4th Session SEISMIC EFFICIENCY OF LARGE STRUCTURES (RECOMMENDATIONS, CHECKING AND SURVEILLANCE)

DISCUSSION

Paper 4/1 R. PRISCU, A. POPOVICI, C. STERE - ROMANIA

"The Consequences of Partially Grouted Joints Upon the Arch Dam Seismic Behaviour"

Principal stresses σ_1 , σ_2 produced by hydrostatic pressure, according to the three analysed variants.

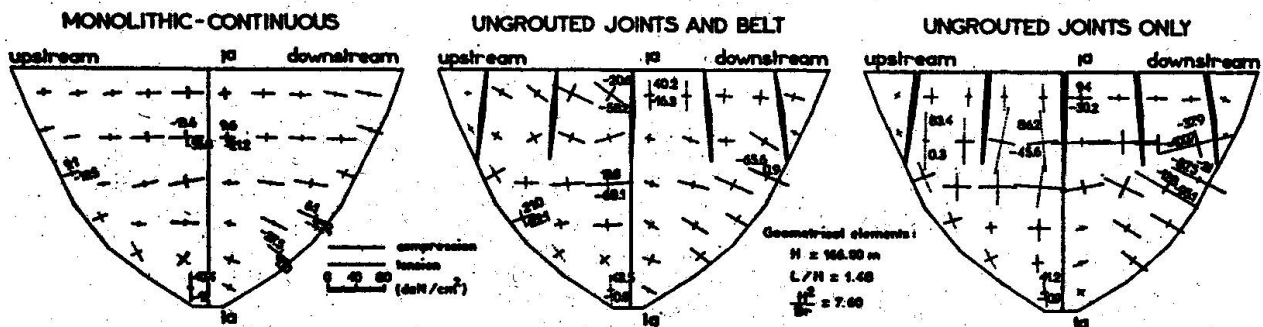
I believe that the ordinates of fig. 4 are all ten times too large and a decimal point should be added; also in fig. 7 I find it difficult to understand the large horizontal stresses in the area where the joints are ungrouted.

The values of the velocity potential function ψ presented in figure 3 are correctly represented. This fact could be properly noticed by making an analogy with the classical relationship of Westergaard. Let us consider for instance the network point (i) of the dam central cross-section, situated at the depth $4 \cdot \Delta z = 132$ m below the crest, whereat the potential function is $\psi_i = 99.6$ m.

The dam structure discretization has been carried out through Clough-Fellipa thin shell finite elements, according to the SAP IV program /6/. The computer program gives out stresses within the element centers. Therefore, in fig. 7, the horizontal and vertical stresses are represented for the medium cross-section of the dam central block (cross-section a-a).

As to have a more complete picture upon the stress distribution of the three considered schemes (monolithic, partial grouted joints with and without stiffening crest belt), in the hereby enclosed figure the principal stresses σ_1 , σ_2 are presented, yielded by the hydrostatic pressure with the reservoir level up to the dam crest.
